# OROVILLE EMERGENCY RECOVERY – SPILLWAYS

## Board of Consultants Memorandum

SUBJECT: Memorandum No. 19

**Figure 1. Photos of the foundation preparation at the upper section of the FCO chute.**

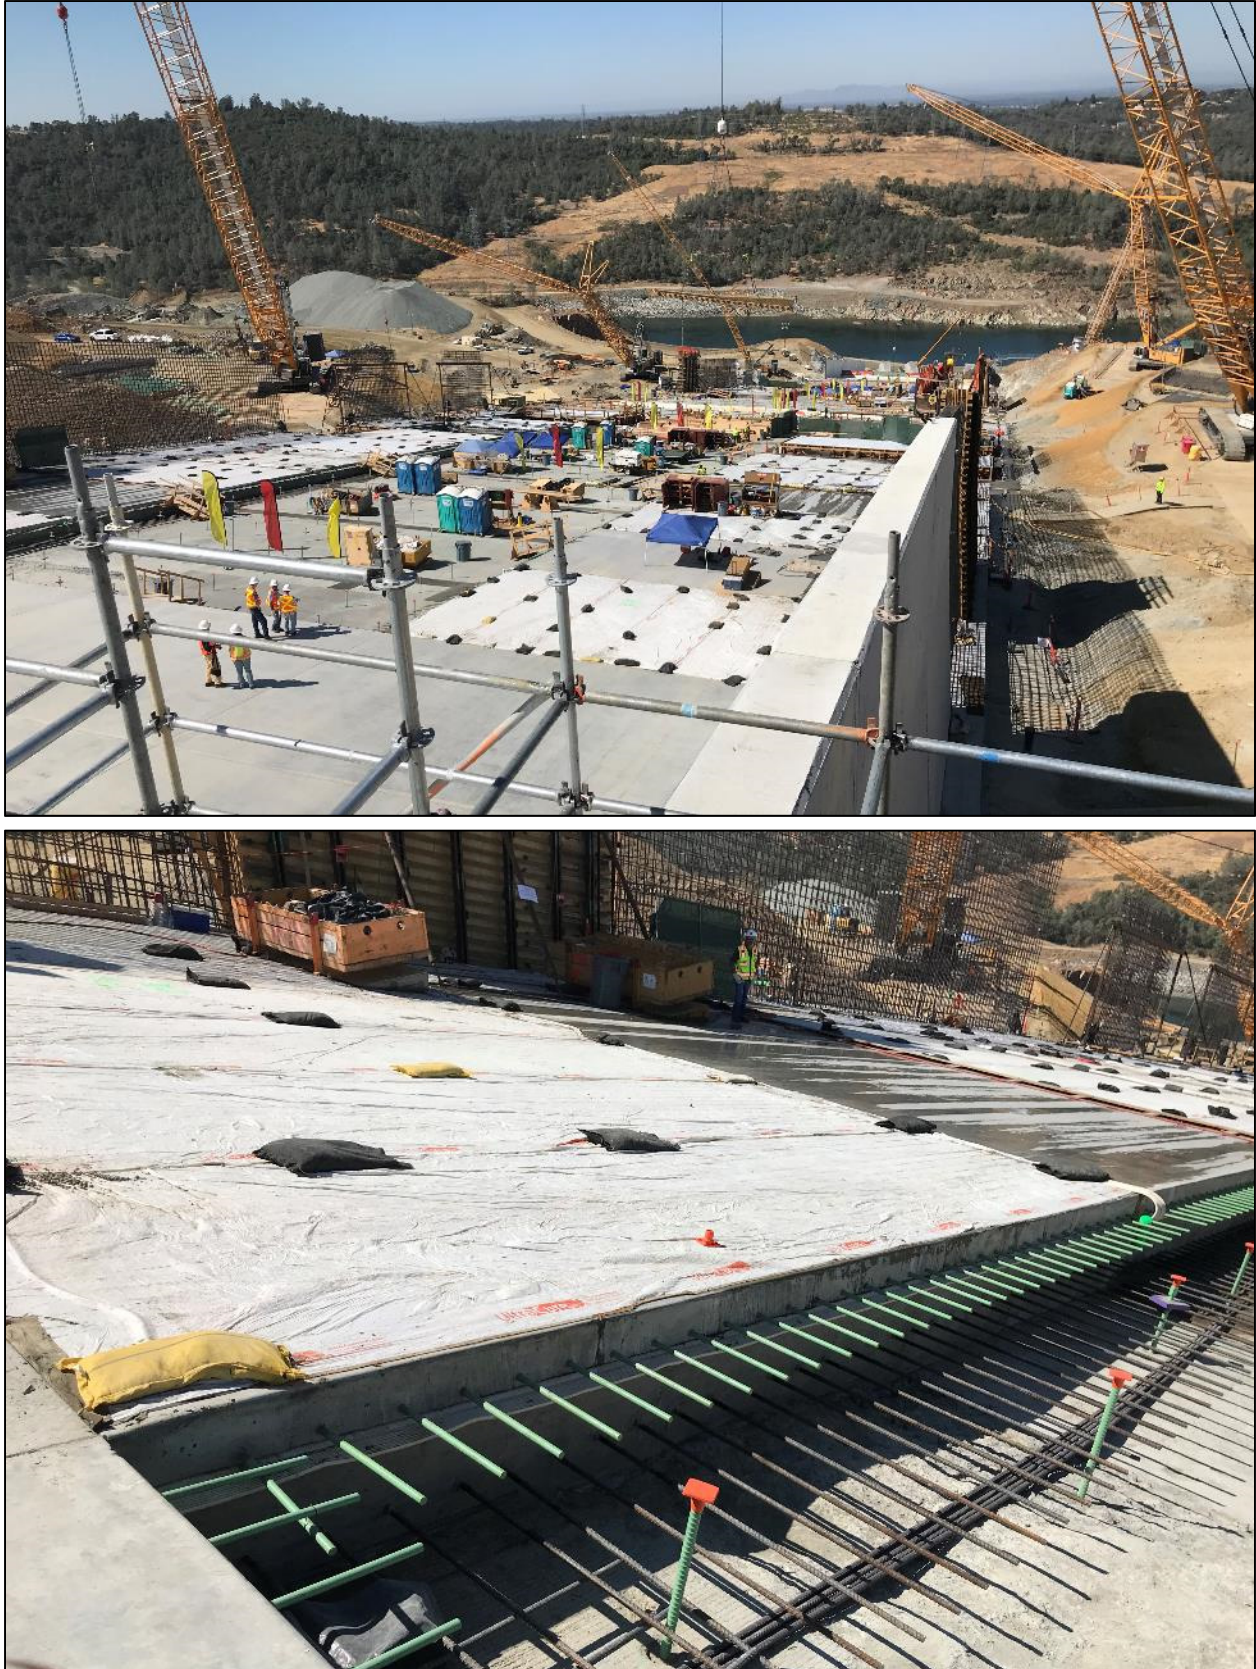
1. Foundation preparation of the upper section of the FCO spillway (see Figure 1);
2. The completed reconstruction of the surface of concrete chute slab (28E) near Sta. 21+00;
3. Placement of chute slabs in the middle section of the FCO chute (see Figure 2);
4. Surface preparation of the FCO dentates (see Figure 3, top photo); and
5. Excavation and foundation preparation for the RCC apron on the left side of the Emergency Spillway (Phase 2).

Select photographs of construction work observed by the BOC are presented on Figures 1, 2 and 3.

The BOC was pleased to see the new concrete slab moist curing method being employed in the middle FCO chute. This method is an improvement over the previous conventional moist curing approach. This, along with the new system used to screed the slabs, will help provide a durable long-term concrete surface. The completed RCC apron for Phase 1 of the Emergency Spillway appears to be of excellent quality. The finish on the exposed RCC stepped surface is exceptional.
